ADDENDUM NO. 2

**WOMEN'S COMMUNITY CORRECTIONAL CENTER
WORK ORDER 39 – WCCC NEW ACCESS ROAD
JOB NO: DCR 24-WCCC-0016
TAX MAP KEY: (1) 4-2-003:004
KAILUA, HAWAI'I**

**FOR AND BY THE DEPARTMENT OF CORRECTIONS AND REHABILITATION
STATE OF HAWAI'I**

DATE OCTOBER 21, 2026

SITE, GRADING AND DRAINAGE PLAN

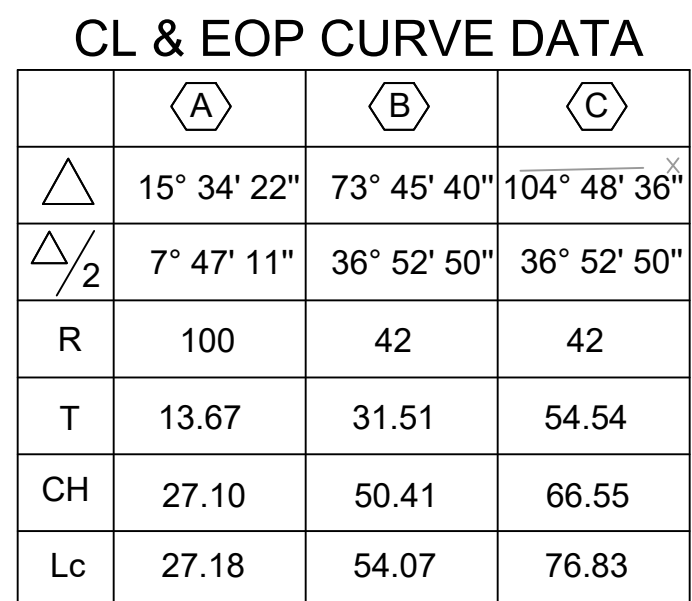
Sheet Group	Sheet No.	Sheet Name or Description
CIVIL	C06	DEMOLITION AND EROSION AND SEDIMENT CONTROL PLAN <ol style="list-style-type: none">1) Revised location of infiltration trench to reduce impact on the existing monkeypod tree.2) Updated “Existing Monkeypod Tree” callout.
CIVIL	C08	SITE GRADING AND DRAINAGE PLAN <ul style="list-style-type: none">• Revised location of infiltration trench to reduce impact on the existing monkeypod tree; revised callouts related to the infiltration trench and swales leading to the trench.• Updated “Existing Monkeypod Tree” callout (same as C06).• Added traffic control signs and markings (Stop and Left Turn Prohibited signs and pavement stop bar).• Added stormwater flow arrows to indicate downstream outfall.
CIVIL	C10	TYPICAL SECTIONS DRIVEWAY ACCESS ROAD “A” <ul style="list-style-type: none">• Updated sections related to the revised infiltration trench layout.

1 ASPHALT PAVEMENT SECTION (WCCC)
NOT TO SCALE

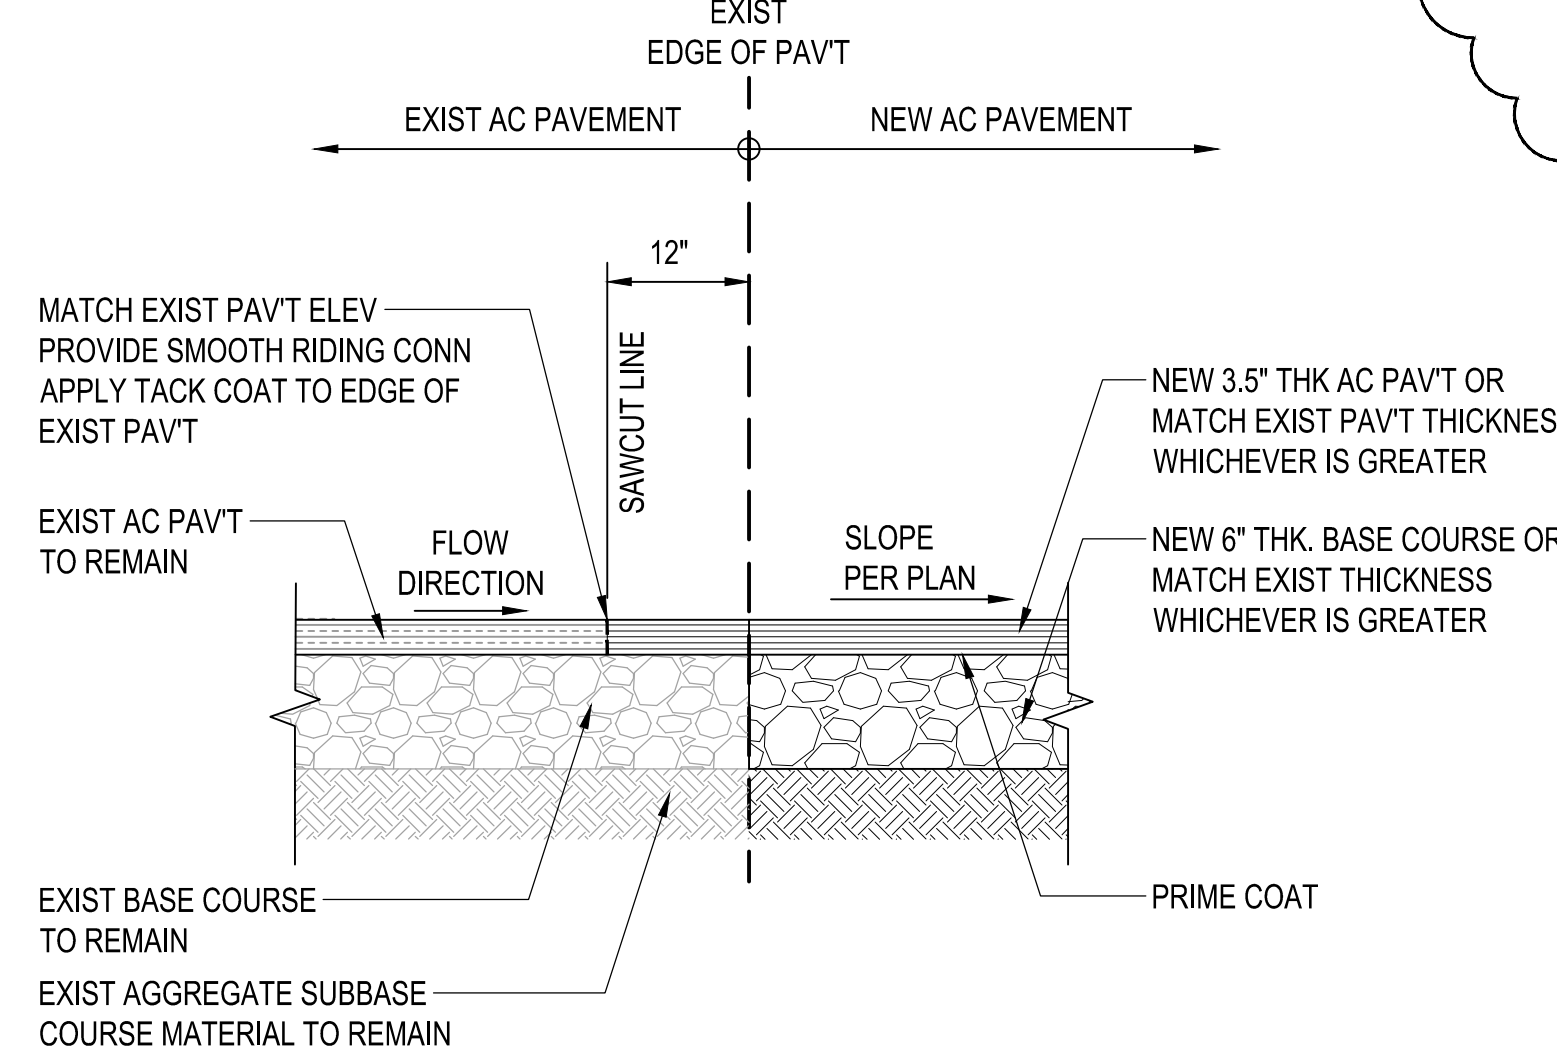
CIVIL	C11	<p>MISCELLANEOUS DETAILS – 1</p> <ul style="list-style-type: none"> • Added root control barrier to the edge of pavement facing the monkeypod tree (Detail No. 1). • Removed root barrier from the infiltration trench detail (Detail No. 5). • Added traffic control sign detail (Detail No. 6). • Revised layout and arrangement of the double swing gate detail (Detail No. 4) to accommodate the sign detail.
CIVIL	C12	<p>MISCELLANEOUS DETAILS – 2</p> <ul style="list-style-type: none"> • Added tree protection fence and notes detail (Detail No. 4). • Revised layout of the bollard detail (Detail No. 3) to accommodate the tree protection fence and notes detail.
